**TO:** City of Orange Township Zoning Board of Adjustment  
**FROM:** Gerard M. Haizel, PP, AICP, Board Planner  
**RE:** **MW-24-004 – 7-11 Berg Place (aka 7-11 Tremont Avenue)  
Block 6106, Lot 19, 20 & 21**  
**DATE:** December 9, 2024 – **REVISED from Report dated December 2, 2024**

On property located within the City's ***MX-1 (Mixed-Use Low Density Residential and Neighborhood Commercial) Zone***, the applicant ***Nwaiwu Properties, LLC***, proposes to construct a new 3-story seven-unit multifamily dwelling on an existing "landlocked" vacant lot. The proposed low-rise multifamily dwelling **is permitted** in the MX-1 zone. However,

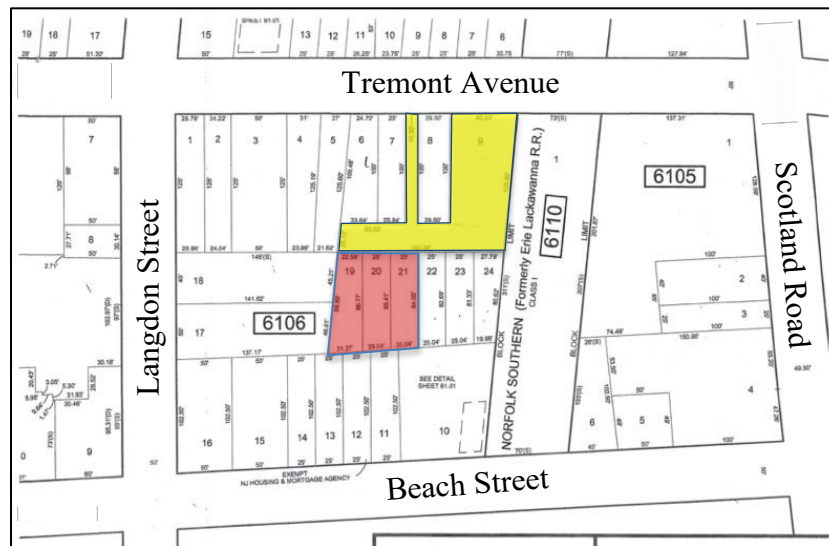
The subject site is located on Berg Place, which is not a City street, but rather private property. The survey submitted as part of this application indicates this. The applicant has also provided a copy of a recorded deed, which also substantiates that the thoroughfare referred to as Berg Place is in fact a part of tax lot 9, of block 6106. See illustration below.

The subject site is depicted in **red** and the “Berg Place” access property is depicted in **yellow** in the illustration above.

**The applicant should provide testimony explaining what they know of this situation with the subject site not fronting on a street and how it came to be. The applicant should further provide testimony disclosing any easement or agreement that provides permission for continued use of the roadway.**
